SERVICE BULLETIN

B-004

NONCOMPLIANCE RECALL 0801 – P/M WHEEL LABELS

Figure 1. Label Placement

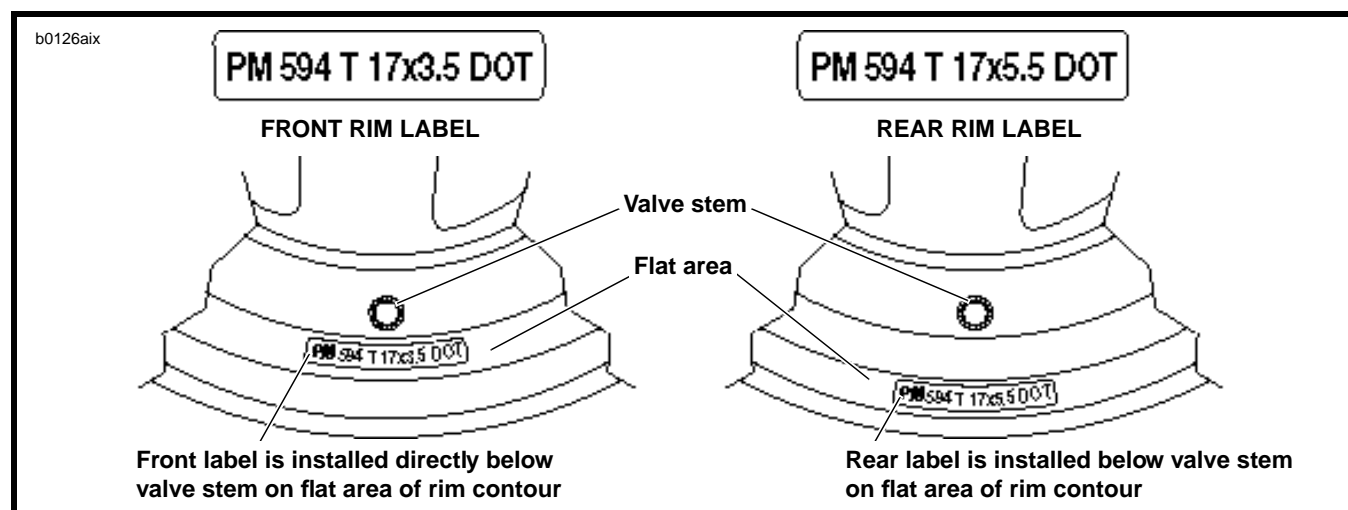
The P/M polished aluminum tire rims do not include the required weather side label markings designating the rim's nominal dimensions, rim size designation and Buell's DOT certification that the rim complies with all applicable motor vehicle safety standards. In addition, the rim does not include the labels which identify the rim manufacturer and the month and year of production.

See Figure 1. In order to meet federal regulations, a label must be placed on the front and rear rim of each affected motorcycle. Follow the instructions below.

Front and rear rim labels are not interchangeable. Match each label to its corresponding rim as shown in Figure 1.

1. Clean rim surface at locations shown in Figure 1.
2. Remove adhesive backing from front label (PM 594 T 17x3.5 DOT). Install front label directly below valve stem on flat area of rim contour.
3. Remove adhesive backing from rear label (PM 594 T 17x5.5 DOT). Install rear label below valve stem on flat area of rim contour.

Figure 2. Label Placement

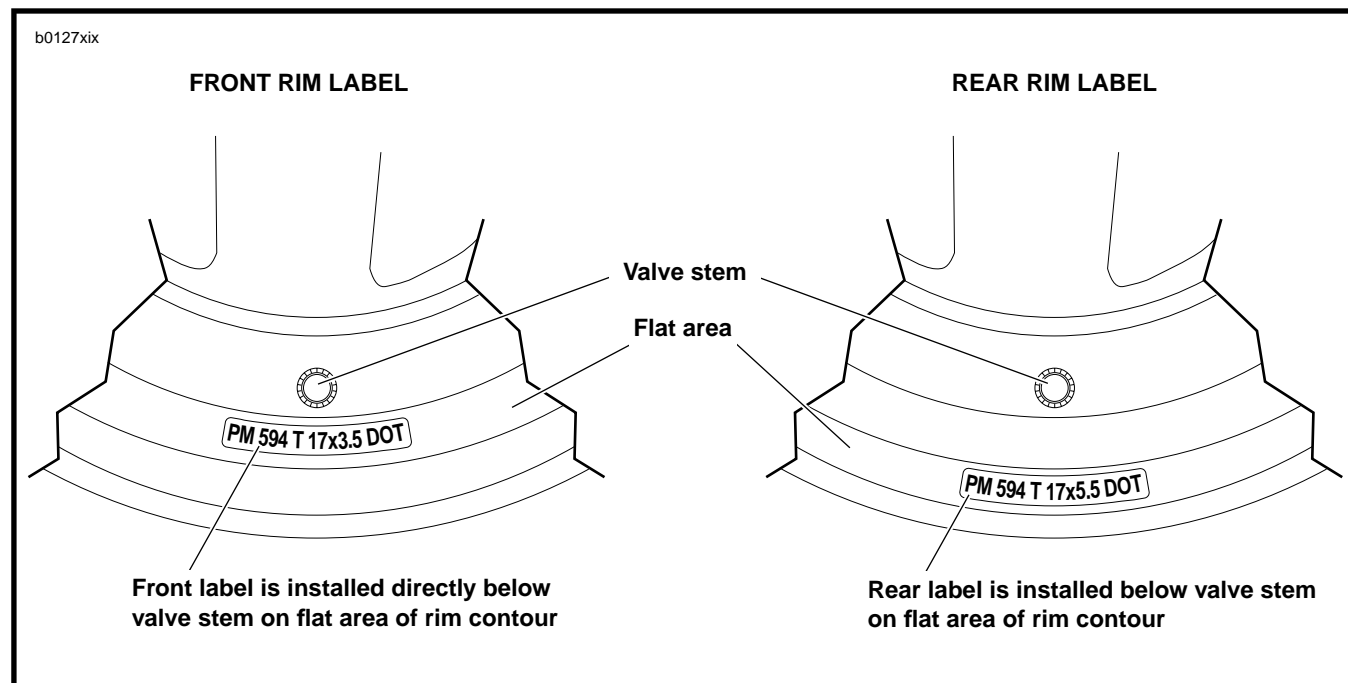
The tire rims do not include the required weather side label markings designating the rim's nominal dimensions, rim size designation and Buell's DOT certification that the rim complies with all applicable motor vehicle safety standards. In addition, the rim does not include the labels which identify the rim manufacturer and the month and year of production.

1. Clean rim surface at locations shown in Figure 2.

2. Remove adhesive backing from front label (PM 594 T 17x3.5 DOT). Install front label directly below valve stem on flat area of rim contour.
3. Remove adhesive backing from rear label (PM 594 T 17x5.5 DOT). Install rear label below valve stem on flat area of rim contour.
